ECE/TRANS/WP.29/GRSP/39
3 July 2006

Working Party on Passive Safety (GRSP)

**REPORT OF THE WORKING PARTY ON PASSIVE SAFETY (GRSP)
ON ITS THIRTY-NINTH SESSION
(15 – 19 May 2006)**

ARRANGEMENTS OF APPROVAL MARKS

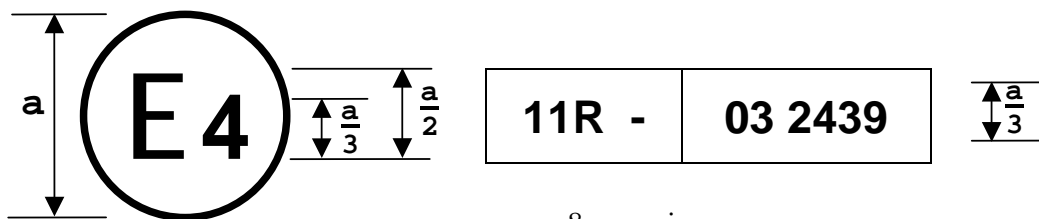
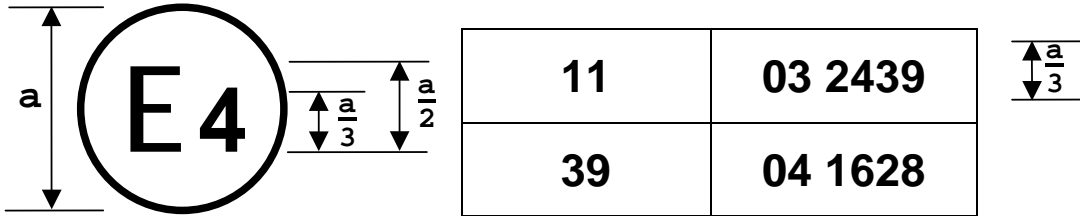
Annex 2, amend to read:

The above approval mark affixed to a vehicle shows that the vehicle type concerned has, with regard to door latches and door retention components, been approved in the Netherlands (E 4) pursuant to Regulation No. 11, as amended by the 03 series of amendments.

The above approval mark affixed to a vehicle shows that the vehicle type concerned has been approved in the Netherlands (E 4) pursuant to Regulation No. 11 as amended by the **03** series of amendments and Regulation No. 39, as amended by the 04 series of amendments 1/.
